**SUBJECT: GUNNISON, COLORADO, PROCESSING SITE – REQUEST FOR
ADDITIONAL INFORMATION RE: DRAFT GROUNDWATER COMPLIANCE
ACTION PLAN**

COMMENTS AND REQUEST FOR ADDITIONAL INFORMATION

DRAFT GROUNDWATER COMPLIANCE ACTION PLAN

GUNNISON, COLORADO, PROCESSING SITE

Figure 1. Uranium plume from Sector 1 and new gravel pit expansion (adapted from the 2018 Annual Verification Monitoring Report for the Gunnison Processing site Figure 2 (DOE, 2019))

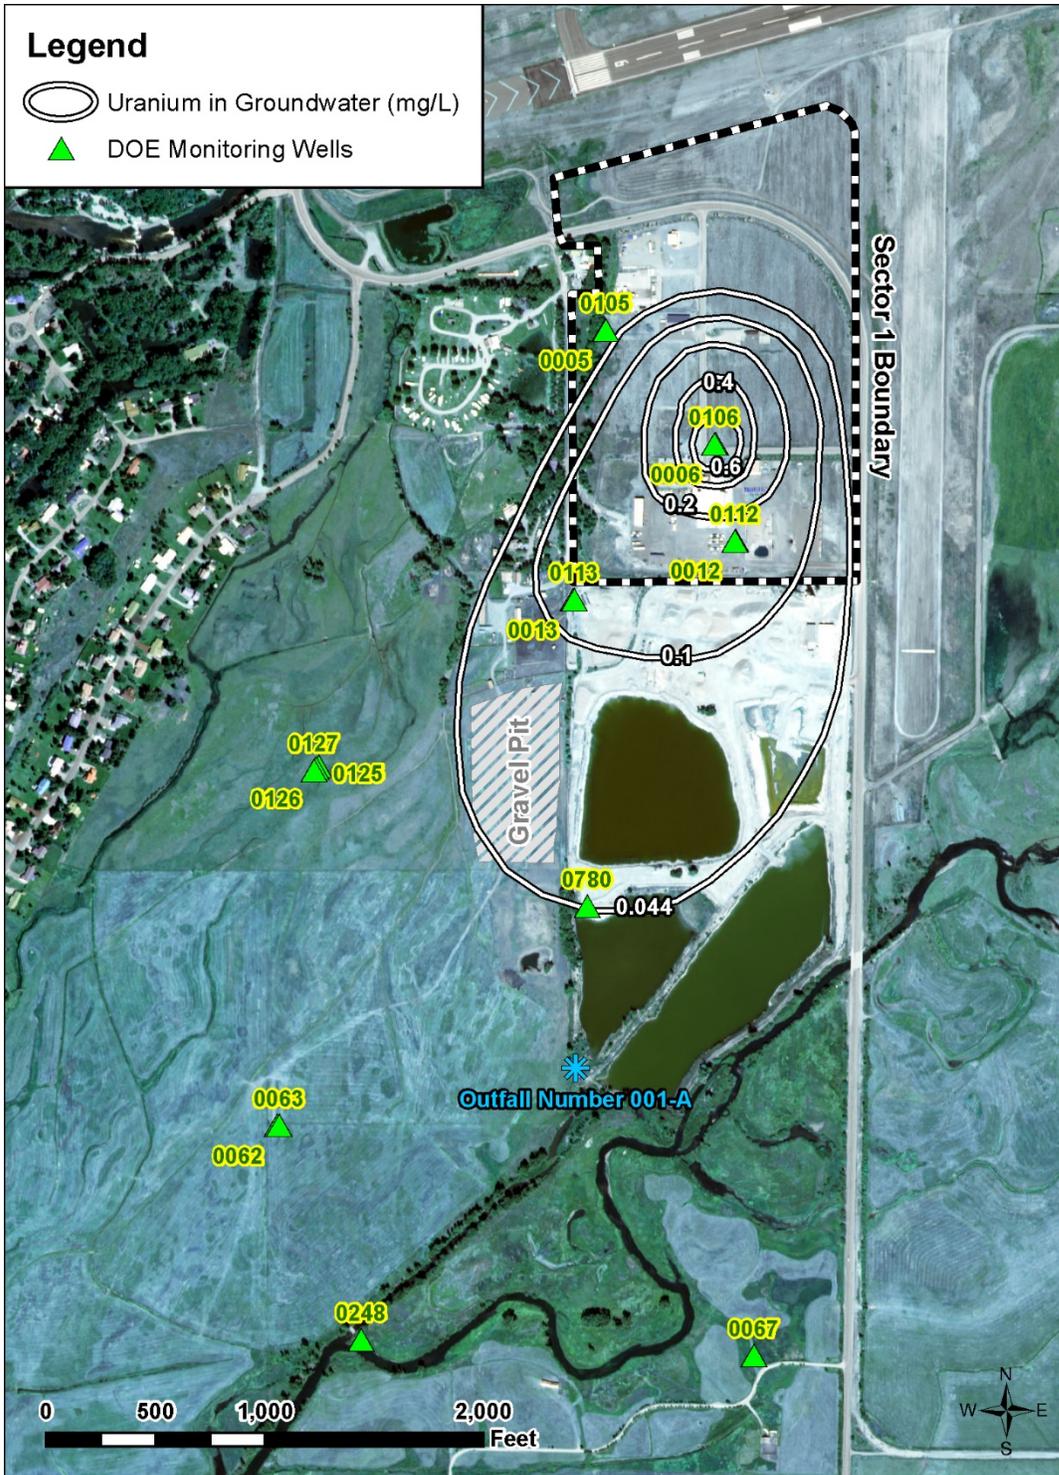
Comment 1: DOE has proposed a uranium Alternate Concentration Level (ACL) of 1.43 mg/l for all groundwater in the alluvial aquifer underlying the original Gunnison processing site boundary, renamed as Sector 1, in lieu of the original natural flushing remedy to the applicable uranium standard of 0.044 mg/l in Table 1 to Subpart A of Title 40 of the *Code of Federal Regulations* (CFR) Part 192 (DOE, 2017). NRC staff finds that the DOE has provided sufficient evidence that the current GCAP of natural flushing is unlikely to meet the applicable uranium standard of 0.044 mg/l uranium in proposed Sector 1. This finding is also supported by the current location of the uranium plume which exceeds the applicable uranium standard of 0.044 mg/l as shown below in Figure 1.

The new Gunnison West Gravel Pit Expansion operation was approved with new dewatering wells. In past gravel pit operations, dewatering wells have operated at rates up to 4000 gpm. These wells represent a new groundwater use south of the Sector 1 proposed ACL site. NRC staff finds the use of any new dewatering wells must be evaluated under present and potential hazard factors in 40 CFR 192.02 c(3)(ii)(B)(1)(iv) and (v). This evaluation is necessary to determine if and how the new gravel pit dewatering wells may impact the uranium plume and the uranium levels at the POE well MW0113 shown in Figure 1. In addition, the new dewatering wells are permitted to discharge to the "Valco Pond" gravel pit and may therefore impact the uranium levels in this gravel pond which are measured at SW0780.

Path Forward: NRC staff requests that DOE analyze the potential impact of any new gravel pit dewatering wells for the approved Gunnison West Pit Expansion. Specifically, DOE should determine if and to what extent the use of these gravel pit dewatering wells may impact the existing uranium plume shown in Figure 1 and the future uranium levels at MW0113. DOE has proposed MW0113 to be the Sector 1 POE well that will be required to meet the proposed Sector 2 ACL of 0.56 mg/l. NRC staff also requests that DOE evaluate any impact on the uranium levels measured at SW0780 in the "Valco Pond" gravel pit which will receive the dewatering well discharge from the new expansion gravel pit operation. The evaluation of this groundwater use and potential surface water impact is needed to meet the requirements of the factors in 40 CFR 192.02 c(3)(ii)(B)(1)(iv) and (v) for the proposed Sector 1 ACL.

Figure 2. Uranium plume from Sector 1 and uranium in downgradient (adapted from the 2018 Annual Verification Monitoring Report for the Gunnison Processing site Figure 2 (DOE, 2019))

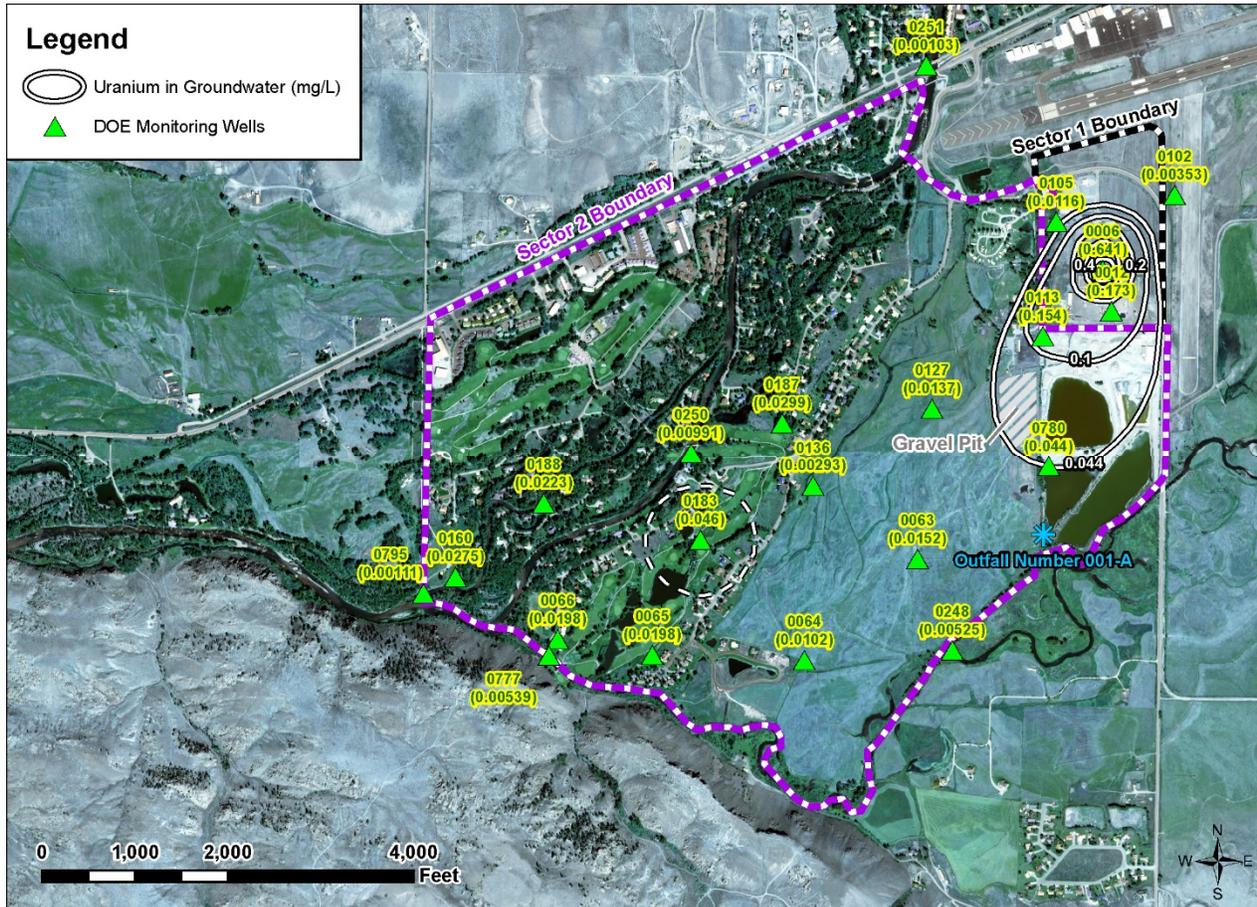
Comment 2: NRC staff does not agree that the current GCAP of natural flushing is failing or will fail to meet the applicable uranium standard of 0.044 mg/l in the entire area of proposed Sector 2 shown in Figure 2 below. In contrast, NRC staff finds the current GCAP of natural flushing is meeting and will continue to meet the applicable uranium standards of 0.044 mg/l for almost the entire Sector 2 area, excluding the area just south of Sector 1. Therefore, NRC staff does not understand the basis for DOE to propose an ACL of 0.56 mg/l for uranium in the entirety of Sector 2 which covers 928 acres (1.45 square miles) with an aquifer thickness ranging from 70 - 130 feet thick. Assuming an average thickness of 100 feet, NRC concurrence on this proposed ACL would permanently affect over 92,800 acre feet of water and is not justified. The NRC staff are concerned with the future use restrictions to such a large area of groundwater.

In Sector 2, the groundwater moves to the southwest from the original Gunnison Processing site at a yearly rate of approximately 690 to 1150 ft/year according to hydraulic conductivity and gradient values provided in the revised GCAP (DOE, 2017). As shown below in Figure 2, the uranium concentrations in the downgradient monitoring wells across Sector 2 are all below the applicable uranium standard of 0.044 mg/l with the exception of a slightly elevated uranium level at MW0183 of 0.046 mg/l.

Figure 3. Uranium levels in MW0113, MW0126 and MW0127 vs. applicable uranium standard (0.044 mg/l)

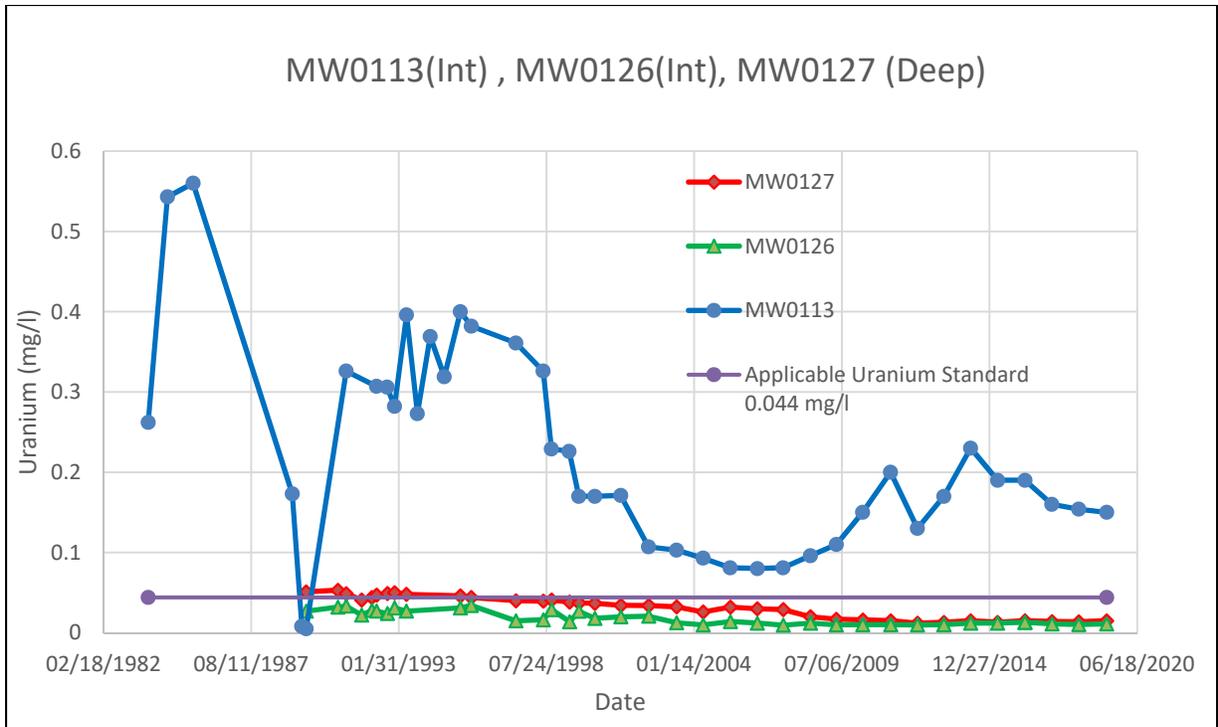
NRC staff's independent review of the monitoring well data for MW0113 is shown in Figure 3 below. The uranium levels in this well showed a significant decrease in uranium from 0.56 mg/l to 0.081 mg/l, from 1985 to 2007. The well then displayed a mild increasing trend up to 0.23 mg/l uranium from 2008 to 2014. However, from 2015 to 2019, the MW0113 data shows the upward trend in uranium has reversed and is now stable around 0.15 mg/l uranium as shown in Figure 3. In addition, the NRC staff's review of wells immediately downgradient of MW0113 showed this increase was not reflected in the downgradient wells, even though it was present for seven years. Specifically, MW0126 and MW0127, also shown on Figure 3, are the closest wells located 1039 feet directly downgradient of MW0113. These wells show significant decreasing trends with natural flushing in Figure 4 and have remained significantly below the 0.044 mg/l uranium standard since 1998. NRC staff review of these wells and of all other downgradient wells in Sector 2 indicate that the anomalous increase in MW0113 was naturally attenuated as predicted and did not impact downgradient wells.

1. The concentration of uranium in MW0113 has remained significantly above the applicable uranium standard as shown in Figure 3.

Figure 5. Example of revised Sector 2 (purple boundary) for proposed ACL (adapted from the 2018 Annual Verification Monitoring Report for the Gunnison Processing site Figure 2 (DOE, 2019))

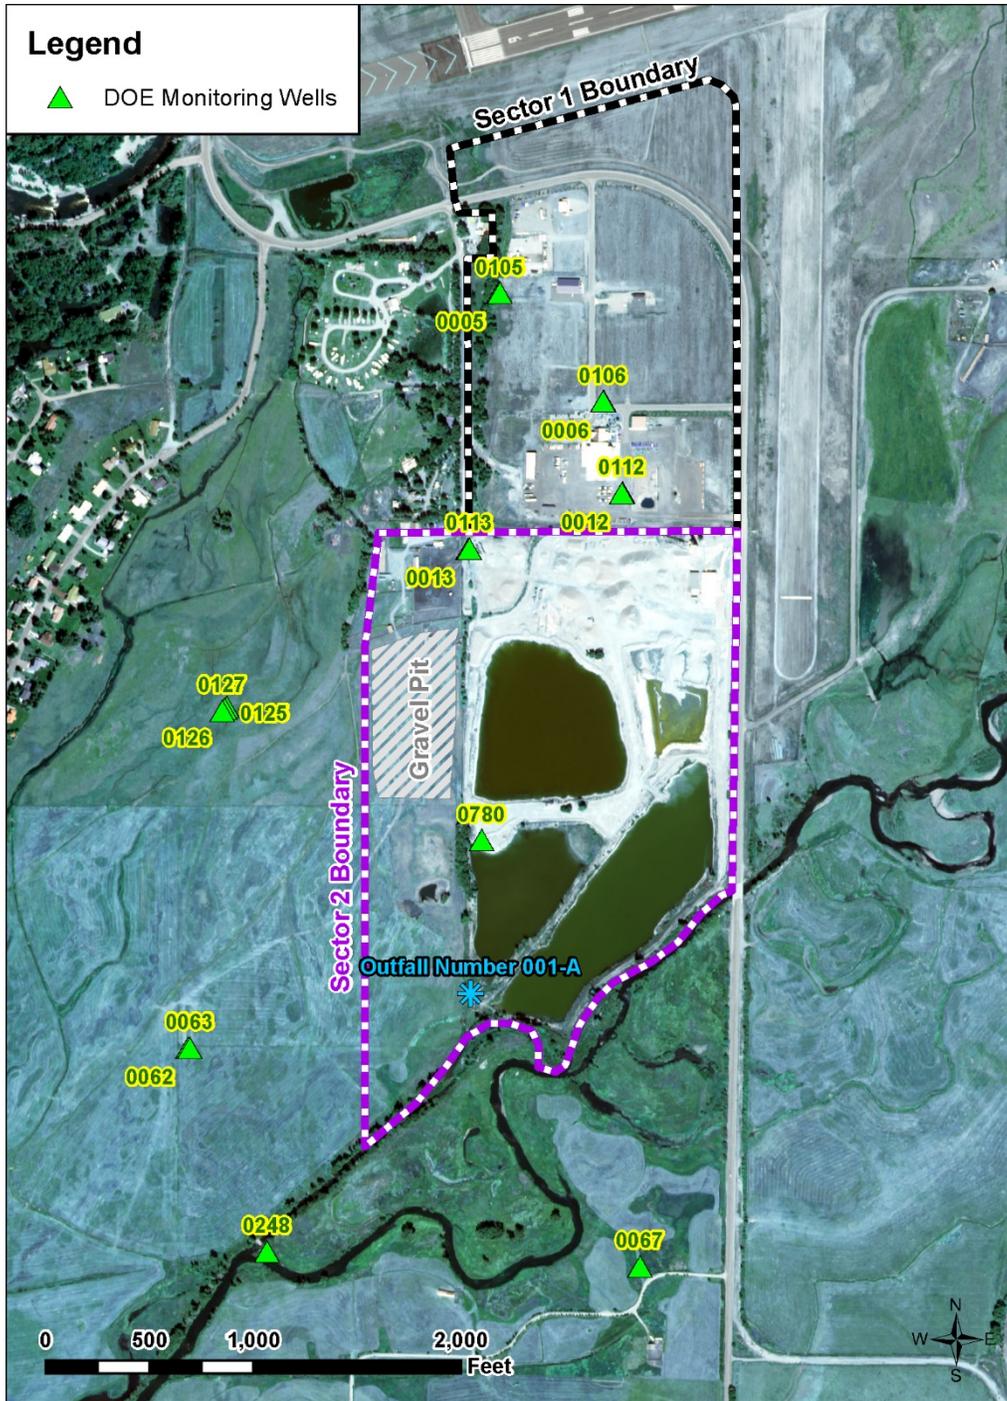
Comment 3: NRC staff requests that DOE propose a revised Sector 2 from the southern boundary of Sector 1 down to Tomichi Creek to include MW0113, the entire gravel pit operation and newly approved Gunnison West gravel pit expansion. An example of such a revised Sector 2 is shown in Figure 5 below. NRC staff finds there is compelling evidence that the alluvial groundwater in this revised Sector 2 will not achieve the uranium applicable standard of 0.044 mg/l in 100 years by natural flushing and therefore a proposed ACL of 0.56 mg/l derived from MW0113 historical uranium values is appropriate.

Basis: NRC staff finds that the proposed ACL of 0.56 mg/l uranium would be reasonable over a revised Sector 2 area extending south from the boundary of Sector 1 to Tomichi Creek and encompassing MW0113 and the new gravel pit operation to the west. An example of a revised Sector 2 area is shown in Figure 5 below.

Comment 6: NRC staff finds that there are no POE wells outside of the institutional control (IC) boundary directly south of the gravel pit operation in revised Sector 2 (Figure 5). A POE well is needed south of this IC boundary to monitor and ensure that unrestricted groundwater use will not pose a substantial present or potential hazard to human health and the environment.

Path Forward: NRC staff requests that DOE should reduce the Sector 2 area for the proposed ACL of 0.56 mg/l uranium to a revised Sector 2 area similar to the one shown in Figure 5 based on DOE’s own assessment.

Figure 6. Uranium levels in SW0248 and SW0780 vs. applicable uranium standard (0.044 mg/l)

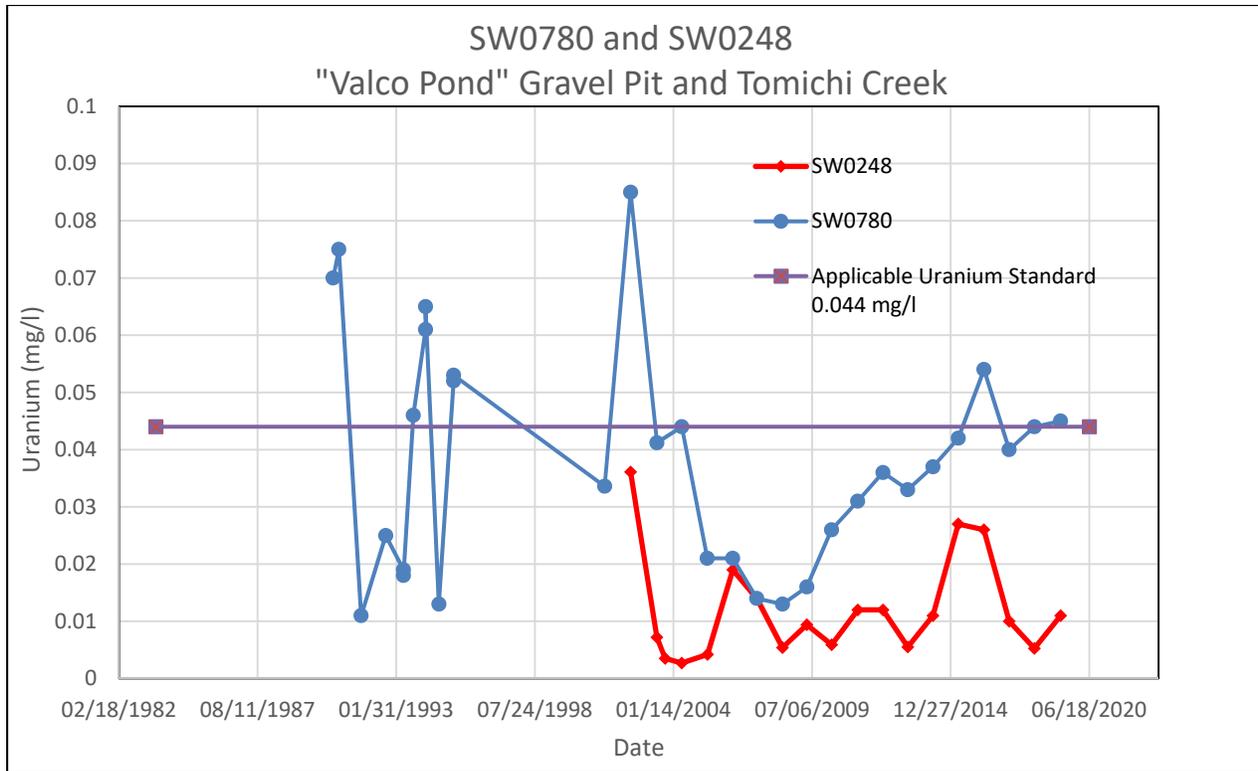
4. The uranium levels in SW0780 over time at the “Valco Pond” gravel pit within this revised Sector 2 have been below the applicable uranium standard of 0.044 mg/l but are now increasing above it as shown in Figure 6 below.

6. SW0248 is appropriate as a surface water POE because it has been consistently below the applicable uranium standard of 0.044 mg/l as shown in Figure 6 below.

Path Forward: NRC staff requests that DOE selects the groundwater well POE locations to be MW0125, MW0126, MW0127 and MW0062 and MW0063 and the surface water POEs to be SW0780 on the ‘Valco Pond’ gravel pit and SW0248 on Tomichi Creek for an appropriately revised Sector 2.

Figure 7. Uranium Trend in MW0067 and MW0082 vs. Applicable uranium standard (0.044 mg/l)

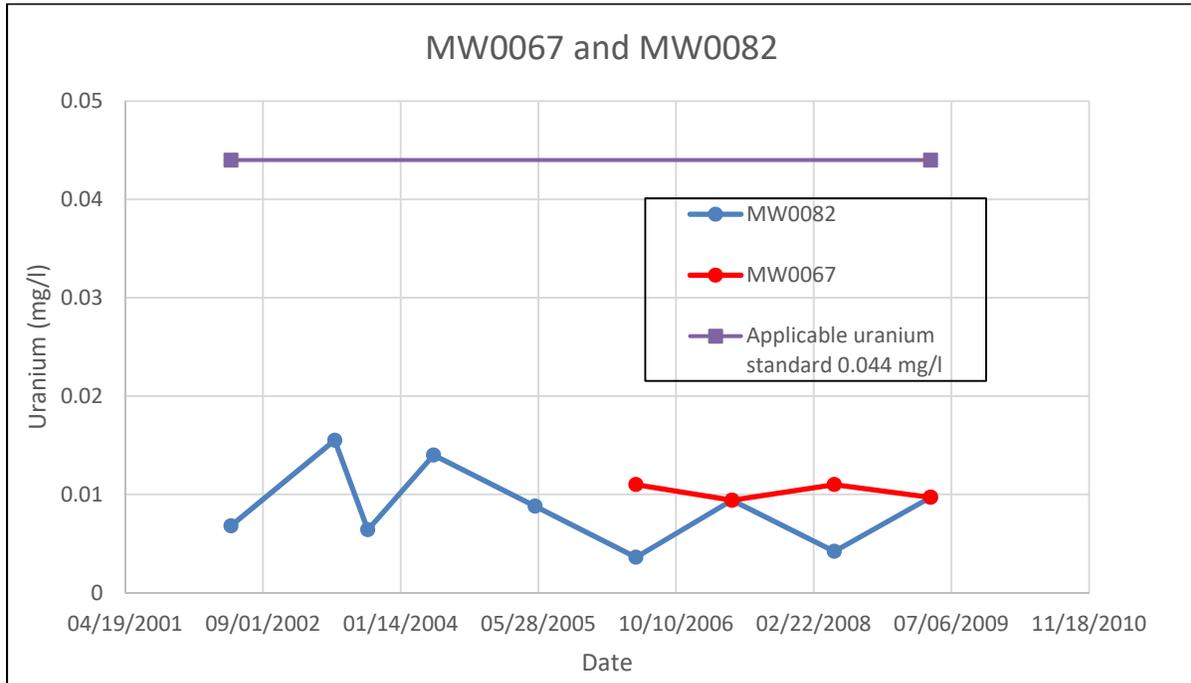
NRC staff finds groundwater must be suitable for unrestricted use downgradient of a revised Sector 2 as there are no ICs beyond this boundary. DOE measured uranium concentrations in private domestic wells MW0080, MW0081, and MW0082 just south of the Sector 2 gravel pit boundary in the past. Some of the uranium measurements in these domestic wells were elevated relative to background, but below the applicable uranium standard of 0.044 mg/l. In 2005, DOE installed MW0067 shown on Figure 5 to verify elevated uranium concentrations measured in

private domestic well MW0082 were representative. DOE monitored MW0067 for four years as shown in Figure 7 below.

DOE has not provided any uranium measurements in MW 0067 since 2008. To concur on an ACL for the recommended revised Sector 2, NRC staff must have an analysis that demonstrates that domestic groundwater users south of the IC boundary for a revised Sector 2 will not be exposed to uranium levels above the applicable standard of 0.044 mg/l.

Path Forward: NRC staff requests that DOE provide an analysis to support the conclusion that uranium concentrations in the alluvial aquifer will not exceed the applicable uranium standard of 0.044 mg/l beyond the IC boundary south of the gravel pit operations in a revised Sector 2. This information should include updated modeling with recent site monitoring data as well as additional groundwater monitoring data beyond the IC Boundary to the south and west of the former processing site in Sector 1. NRC staff also requests that DOE add a POE well, such as MW0067, if it still exists or install a new POE well in this area to verify that the proposed ACL for Sector 2 is protective of private well users.
